Access Compliance Report

Public Rights-of-Way

Intersection ID: 54422	Main Street: LISMORE_LN	Cross Street: KILKENNY_DR	Location: W
ADA ID: C1B23986E736	Ramp Type: Directional1	Initial Pass/Fail: Fail	Overall Compliance: No
			Severity Score: 13.75

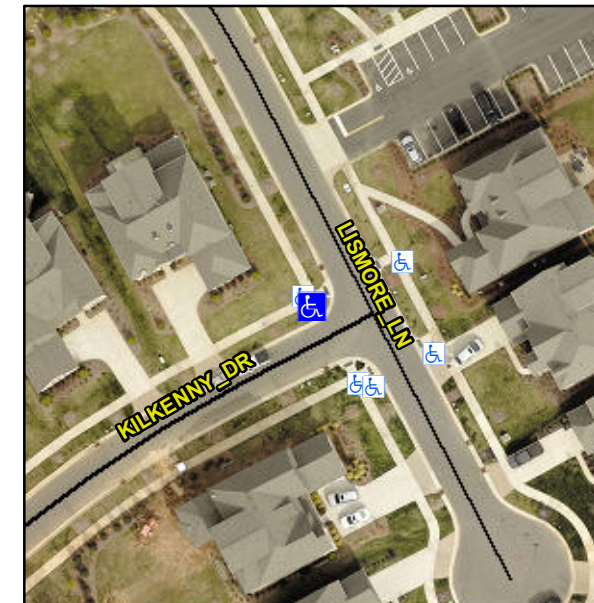
R304.2.2, R304.5.3

Compliance	Description	Data	Compliance	Description	Data
N/A	Ramp Length (in)	84.0	N/A	Grade Break?	N/A
Yes	Ramp Width (in)	57.0	N/A	Grade Break Slope (%)	0.0
No	Ramp Slope (%)	9.0	N/A	Grade Break XSlope (%)	0.0
No	Ramp XSlope (%)	2.1			
N/A	Flare Type LT	N/A	N/A	Flare Type RT	N/A
N/A	Flare Slope LT (%)	N/A	N/A	Flare Slope RT (%)	0.0
N/A	Flare Traversable LT?	N/A	N/A	Flare Traversable RT?	N/A
N/A	Landing Length (in)	0.0	N/A	DWS Provided?	N/A
N/A	Landing Width (in)	0.0	N/A	DWS Contrast?	N/A
N/A	Landing Slope (%)	0.0	N/A	DWS Length (in)	N/A
N/A	Landing X Slope (%)	0.0	N/A	DWS Full Width?	N/A
N/A	Landing Curb? (Y/N)	N/A	N/A	DWS Offset LT (in)	N/A
N/A	Shared Landing?	N/A	N/A	DWS Offset RT (in)	N/A
N/A	Gutter Ponding?	0.0	N/A	Gutter Slope (%)	N/A
N/A	Gutter Lip Ht (in)	2.0	N/A	Gutter X Slope (%)	N/A
N/A	Painted X Walk1?	No		Road Slope (%)	0.1
	X Walk 1 Direction	To SE		Road X Slope (%)	2.0
	X Walk 1 Width (in)	N/A		Clear Space?	N/A

Remove & Replace Entire Ramp.
